Ref. No. 201312035  
Petition No. 2991  
(REVISED)

PETITION NO. 2991  
 Ss. PETER AND PAUL JESUIT CHURCH AND WARMING CENTER  
 438 SAINT ANTOINE STREET  
 DETROIT, MICHIGAN 48226  
 PHONE NO 313 961 8077

REQUEST FOR ENCROACHMENT  
 INTO ST. ANTOINE ST.  
 50 FEET WIDE  
 (With Stair and Ramp)

CITY OF DETROIT CITY ENGINEERING DEPARTMENT SURVEY BUREAU	
JOB NO.	01-01
DRWG. NO.	X 2991

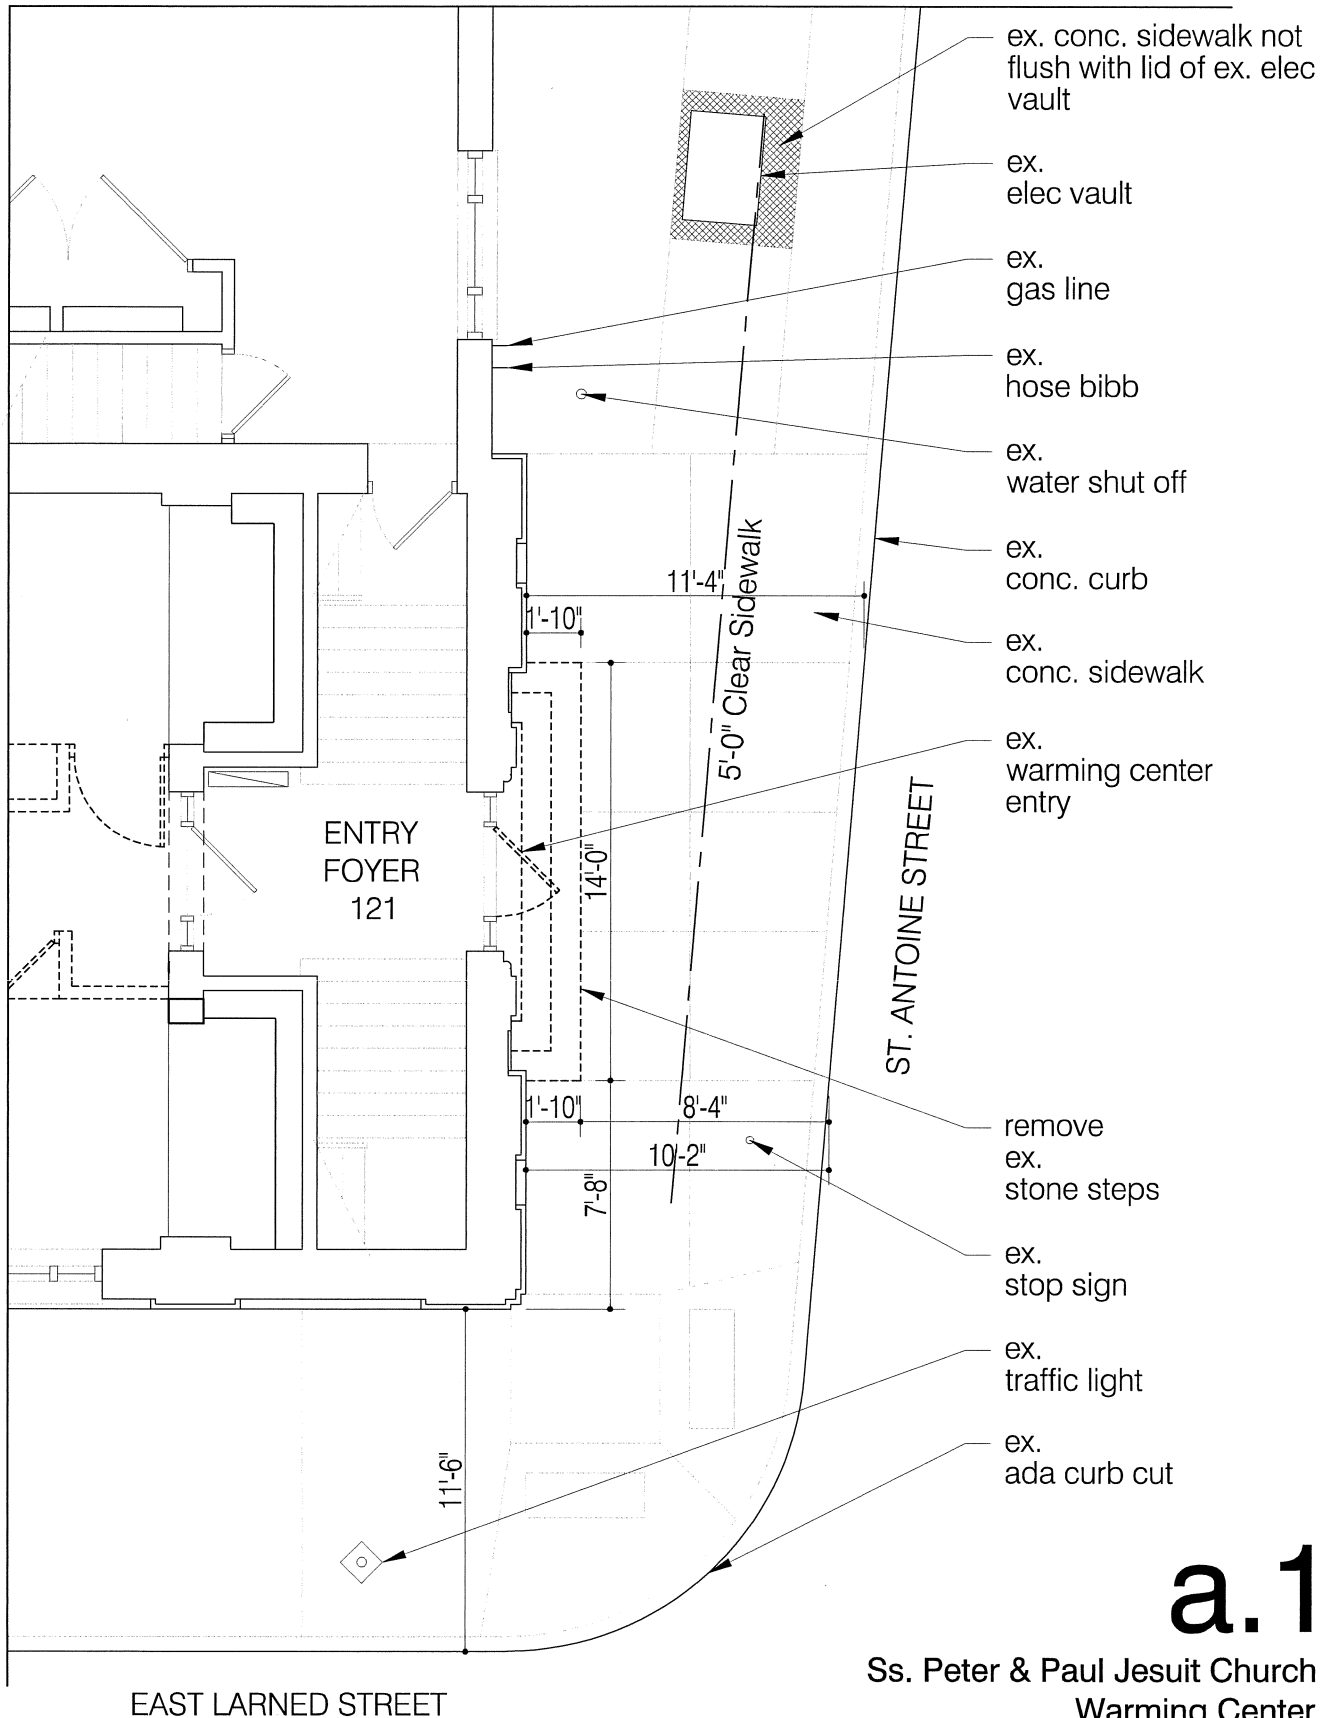
- ( ) Involved; the nature of our services, and the estimated costs of removing and/or rerouting such services are:
- (x) Involved; have no objection to the request for encroachment into St Antoine St. 50 feet wide (with stair and ramp) as shown in drawing X2991.dgn, dated 12/13/2013 and as shown on the attached layout plans revised on 3/30/2015, provided that the following conditions are met with:

- (1) A minimum clear sidewalk width of 5 ft shall be maintained in front of the stair and ramp encroachment at all times to allow for pedestrian traffic.

- (2) The petitioner shall be responsible to construct a concrete sidewalk adjacent to/around the existing electric vault located south of the proposed encroachment. The sidewalk shall be finished and made flush level with the sidewalk surrounding it.
